Date May 11, 2023  
To Town of Cumberland Planning Board  
From Carla Nixon, Town Planner  
Subject **Site Plan Amendment – Solar Field Installation - LGC - 221 US Route 1**

Subject: Lands and Conservation Commission Review for Site Plan Application Amendment  
LGC Clinical Diagnostics – Solar Array  
221 US Route 1, Cumberland, Maine

PLANTING PLAN (C1)  
1" = 20'

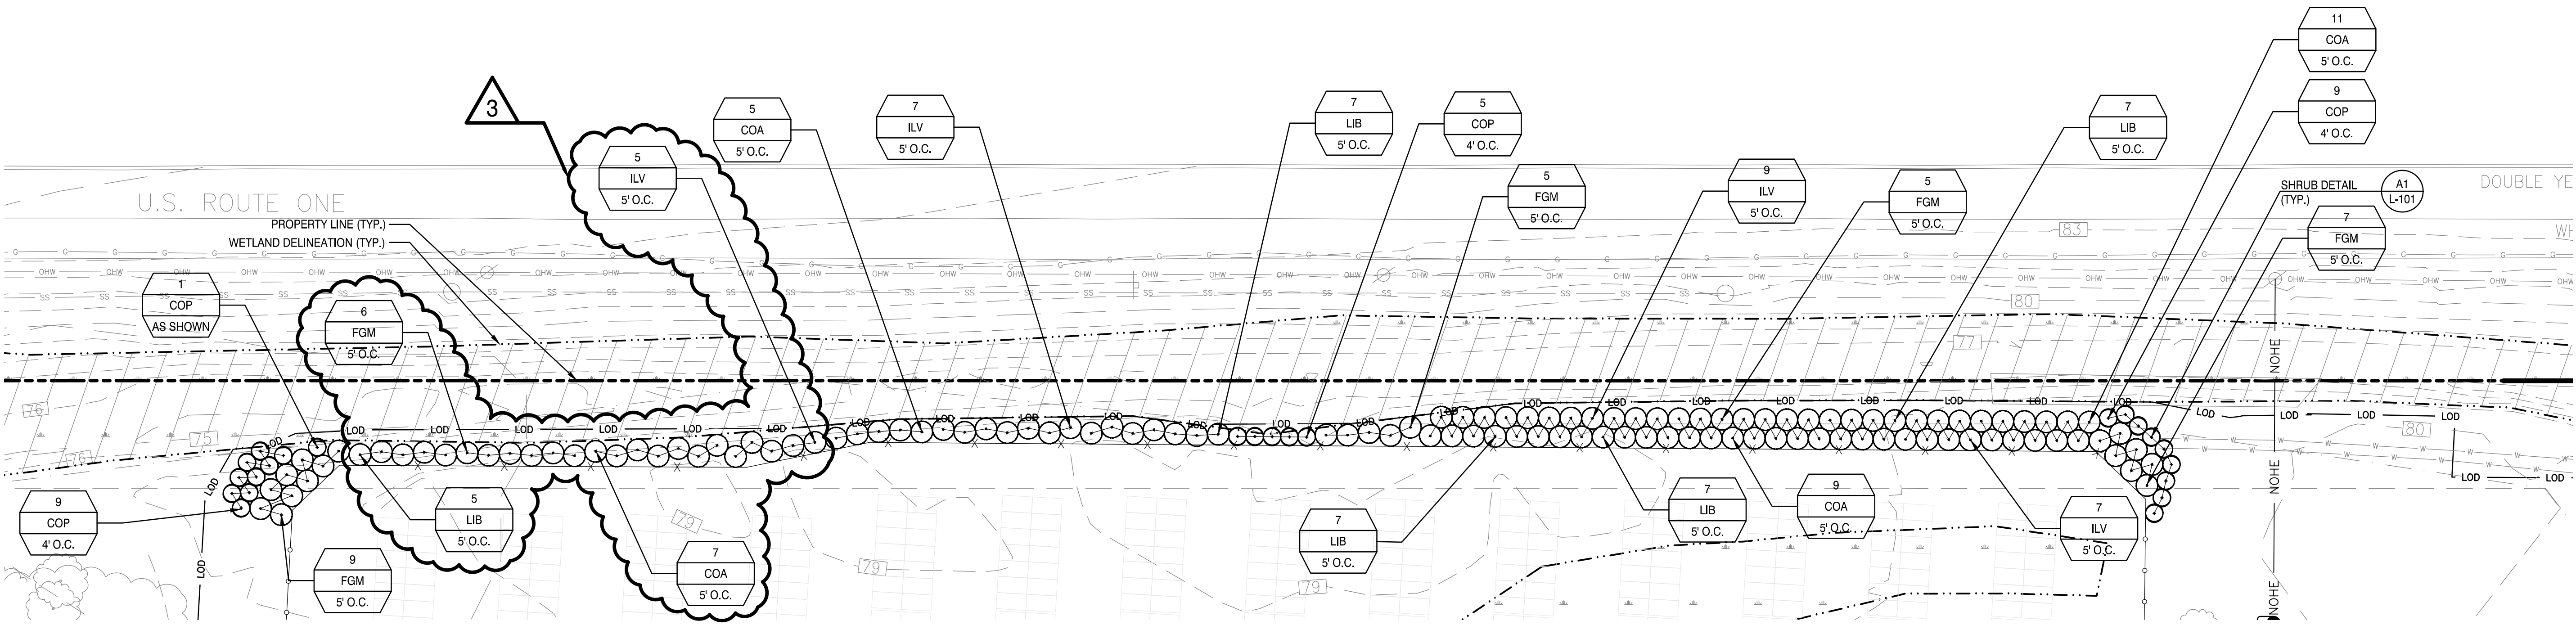
1. Site Plan – SP-1
  - a. There may be proposed plantings over the existing water lines. SME recommends having the water lines surveyed or field verify water line location to coordinate plant locations and avoid conflict with the water line.

NOTE:  
FIELD VERIFY WATER LINE LOCATION. FIELD COORDINATE  
PLANTINGS TO AVOID CONFLICT WITH WATER LINE.

**Response: Proposed plantings are container grown shrubs in #3 pots which are 10” in depth. Proposed excavations for plant pits will be a maximum of 15” deep. Water line will be field located to allow for installation of fence posts as noted on sheet C-102. Note added to landscape plan to field coordinate plant locations as well.**

POST BASE  
NOT TO SCALE

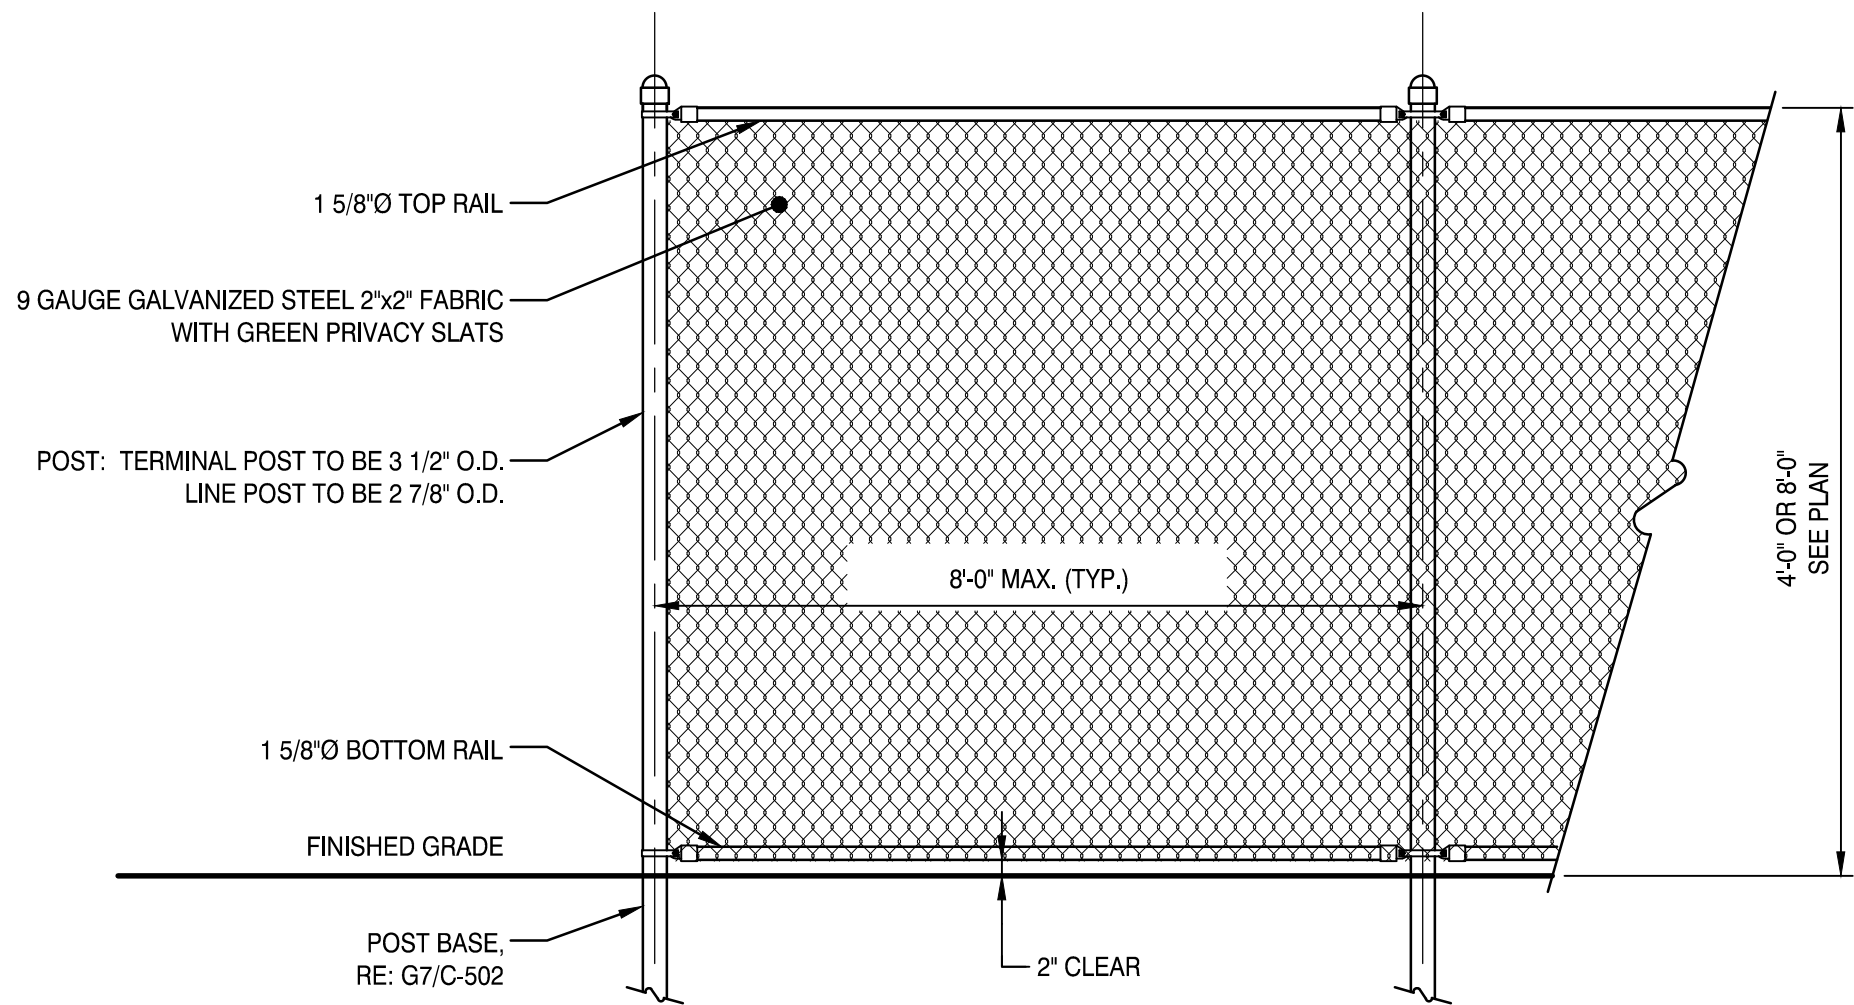
3. Site Details – Sheet C-502
  - a. The Post Base detail may not be deep enough for be below frost. SME recommends the Applicant confirm that the Post Base is below frost.

PLANTING PLAN (G1)  
1" = 20'

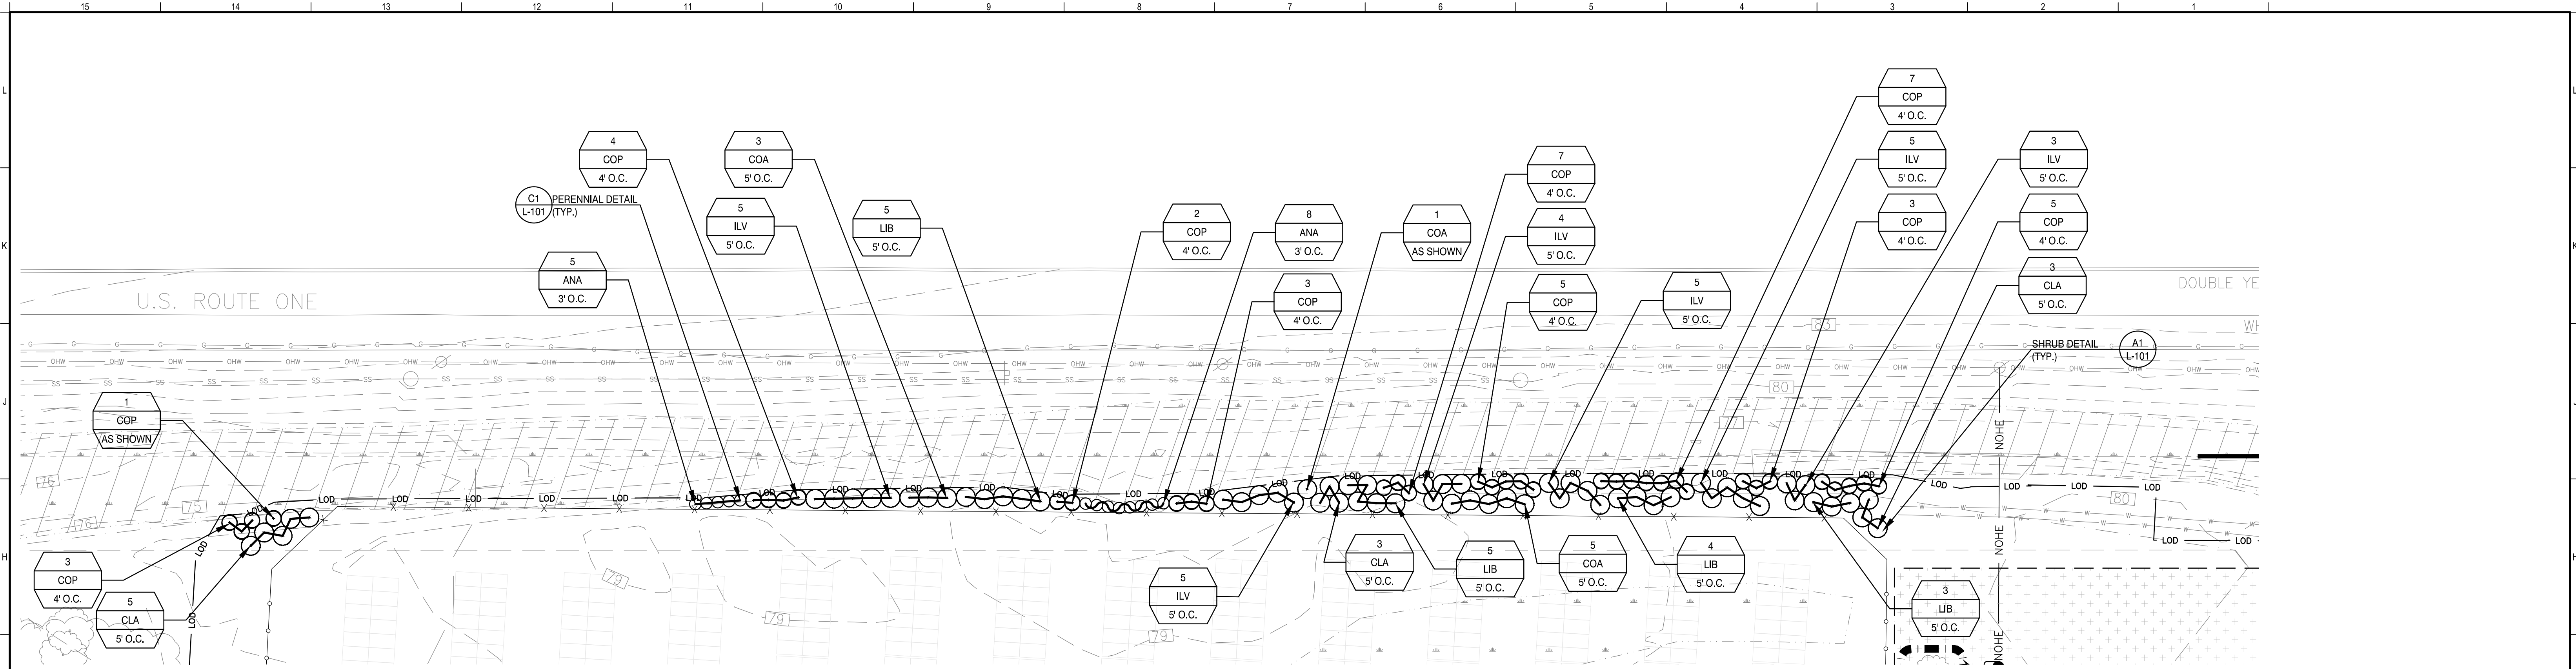
*We believe the viewshed along Route 1 would be better protected by requiring plants that would grow taller than either the solar panels or the 6-foot fence as well as have sufficient spread to also conceal the fence. In looking at the proposed plants, depending on the variety planted, some should grow to cover the fence, others, such as Queen Anne's Lace, most likely will not. Also, the plantings covered only a portion of Route 1; nothing was proposed along Powell except an agricultural fence. Again, the viewshed would be better served if the area along Powell were also covered with sufficient screening plants to cover the fence. The other benefit of taller and denser plantings would be to restore some of suppression of traffic noises to the nearby residential properties.*

- a. US Route One Buffer - The panels are 6-feet tall and the chain link fence with privacy slats along US Route One is also proposed to be 6-feet tall. Since the site sits below the elevation of US Route One by approximately 4-feet, it is likely that the views from a car or pedestrian level will look over the top of the proposed fence and down into the array. Please confirm that the fence will fully screen the array, or that the plantings will grow to a height to screen the array.

**Response:** The fencing and the plantings were selected to provide some screening from Route 1 though not tall enough to impact the western solar exposure. As noted above, the panels are sloped to face south with over half of the panel height below 6' above grade. Adding height to the fence or plantings will create undesired shade on the lower portion of the panels and reduce electrical output.
